SERVICE BULLETIN

SB05-8A

SUBJECT: IMPROVED CAMSHAFT GEAR P/N 656818

PURPOSE: To announce the production of an improved camshaft gear P/N 656818 which supersedes the current camshaft gear P/N 656031

FIGURE 1
UN-MODIFIED PERMOLD CRANKCASE

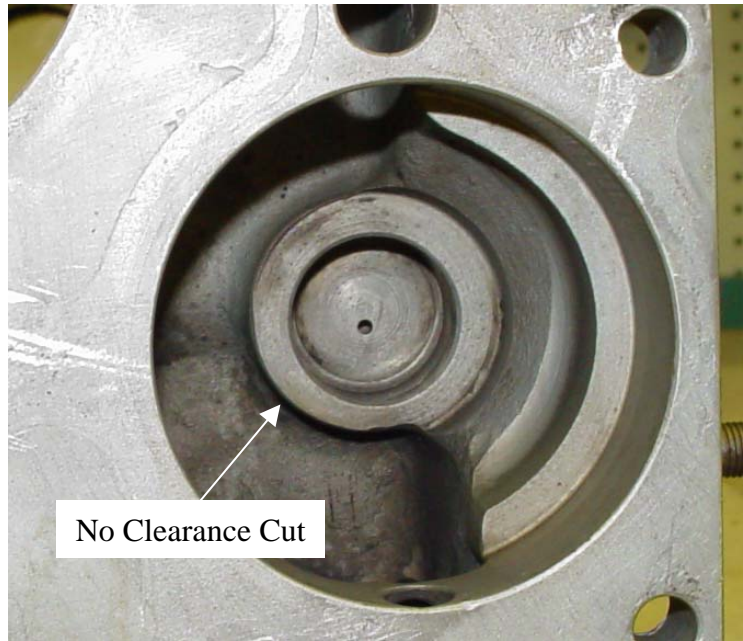
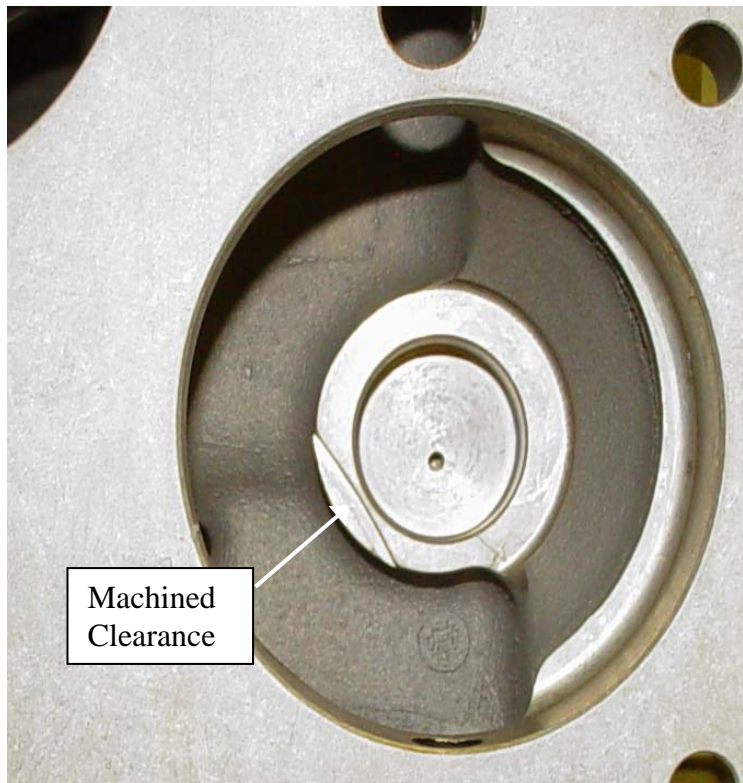
The P/N 656818 camshaft gear is nominally 0.060" wider than the P/N 656031 camshaft gear. On engine models utilizing the Sandcast style crankcase, the P/N 656818 camshaft gear may be installed as a direct replacement for the P/N 656031 camshaft gear. On engine models utilizing the Permold style crankcase, modification of the starter adapter shaftgear bearing boss is required to provide clearance for the wider camshaft gear.

CAUTION... Installation of the new P/N 656818 gear in an unmodified permold style crankcase will result in damage to the gear and/or the crankcase

FIGURE 2
MODIFIED PERMOLD CRANKCASE

FIGURE 3
PERMOLD CRANKCASE MODIFICATION

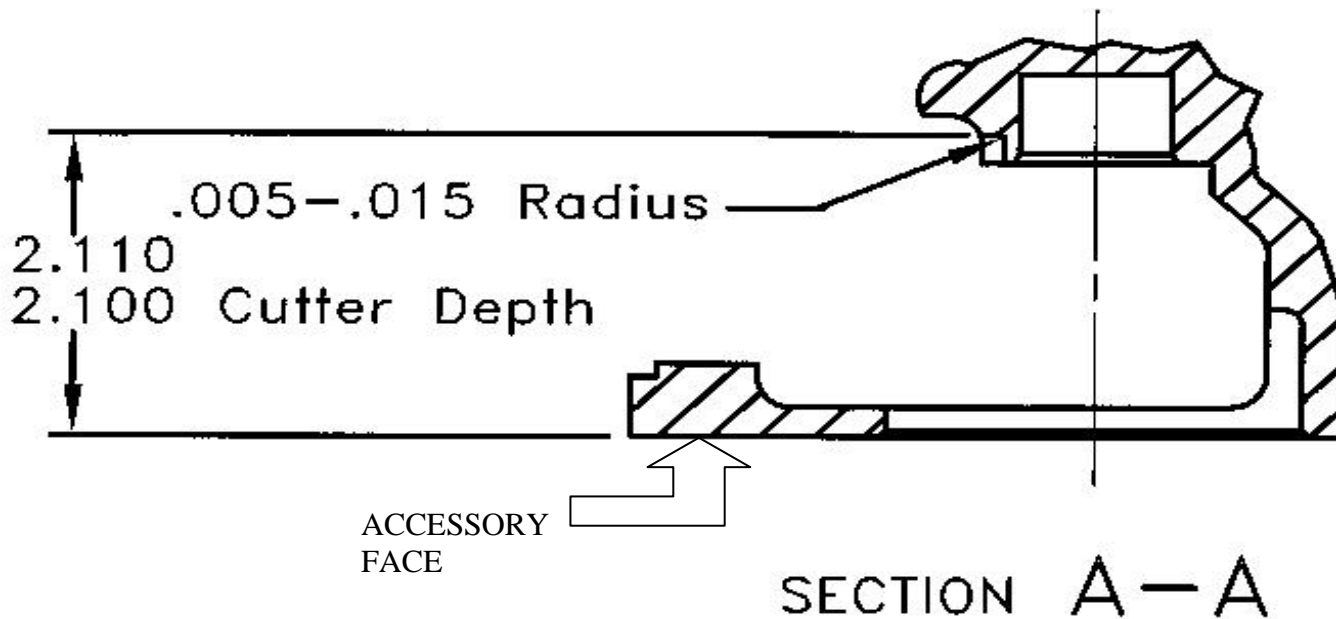
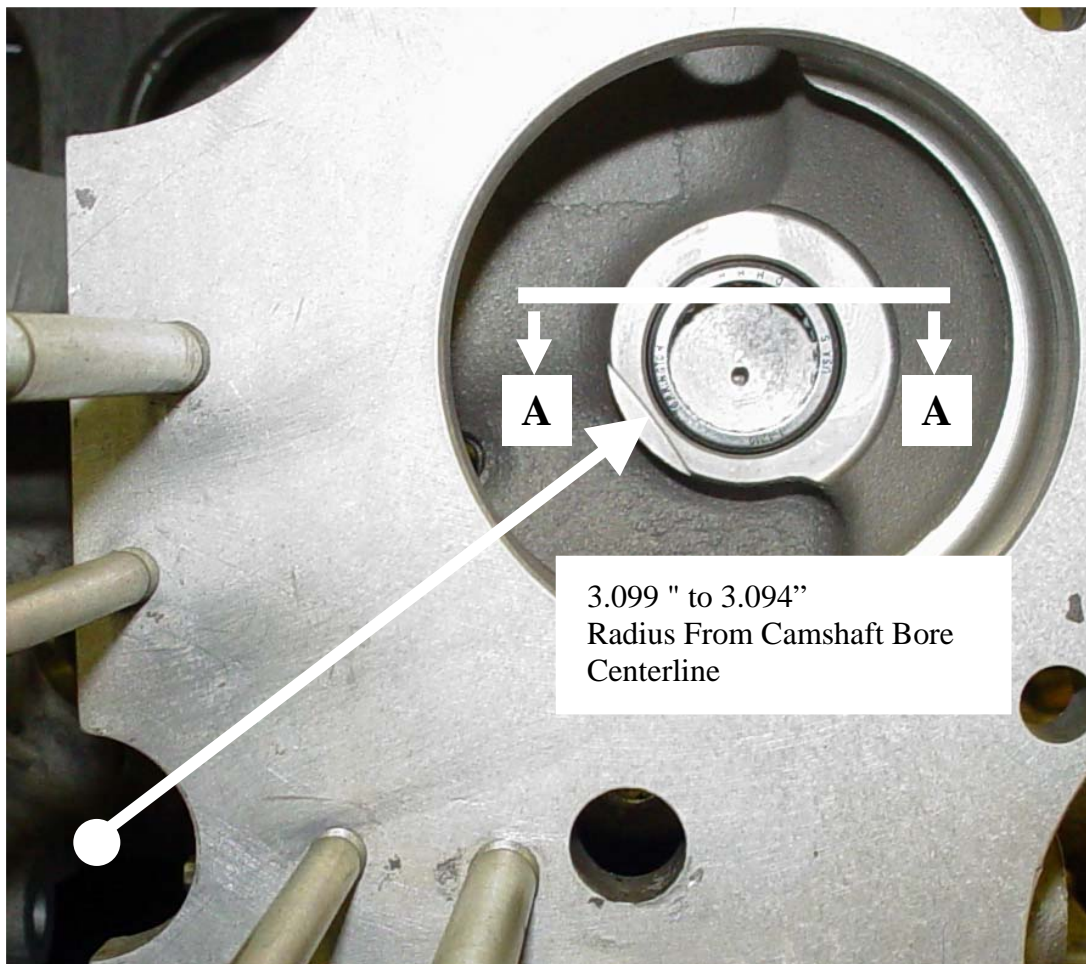
The Permold style of crankcase must be modified to allow use of the new, thicker camshaft gear. A clearance cut is made in the starter drive bearing boss in accordance with the dimensions shown in Figure 3. TCM recommends that a properly certified repair station machine the required clearance.

FIGURE 4
INSTALL CAMSHAFT IN CRANKCASE HALF
INSPECT FOR MINIMUM OF .030 CLEARANCE BETWEEN THE CAMSHAFT
GEAR AND THE END OF THE OIL GALLERY PLUG (WHERE INDICATED).

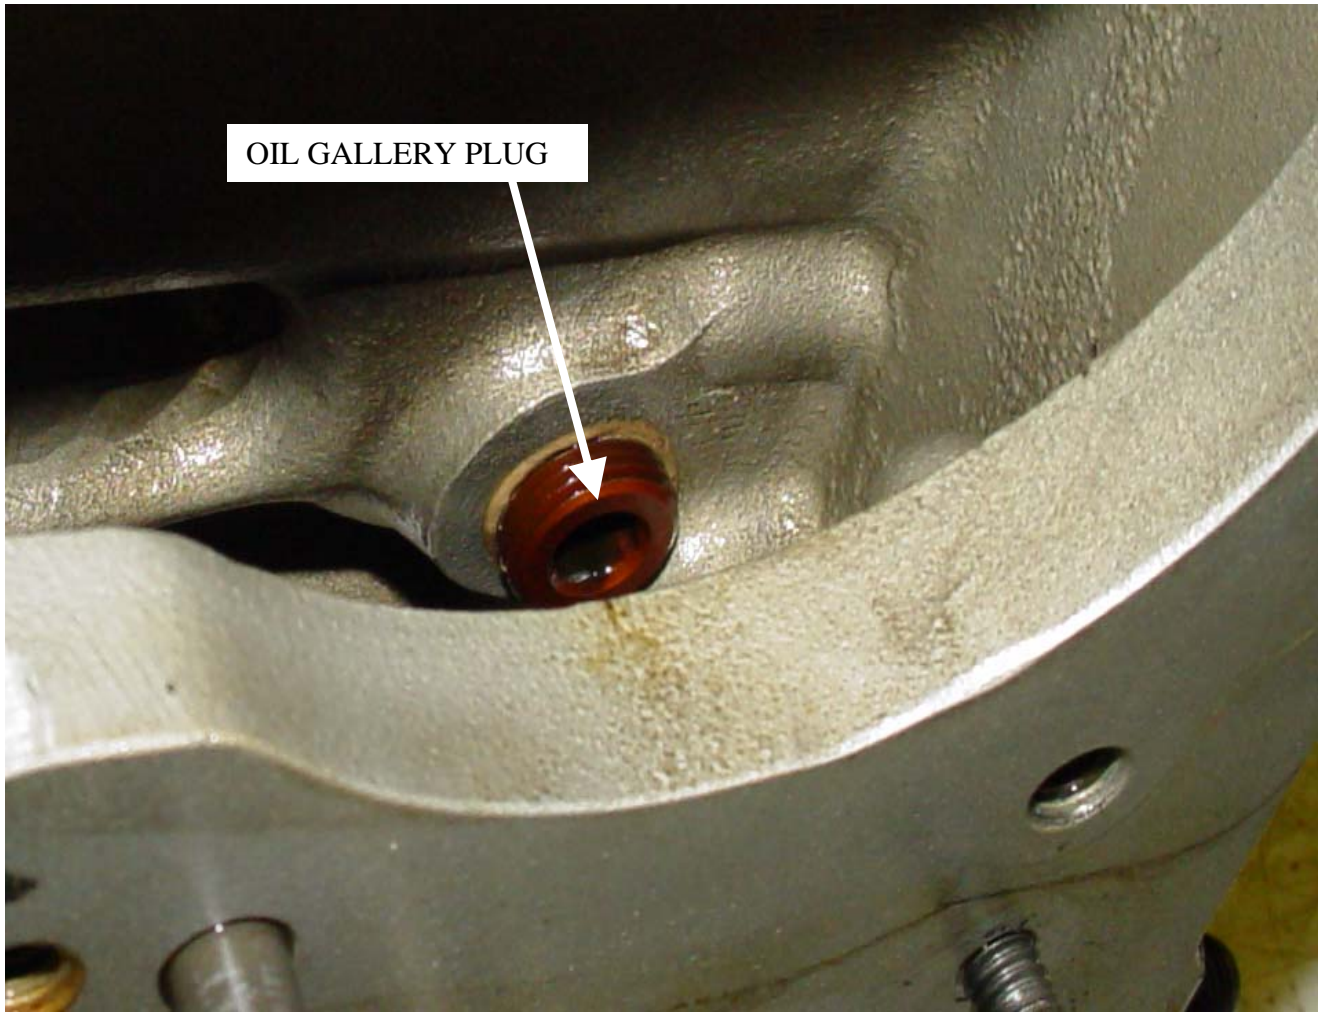
NOTE... On Sandcast crankcase installations clearance must be verified between the new P/N 656818 camshaft gear and the oil gallery plug located directly below the starter adapter boss.
 (Reference figure 4.)
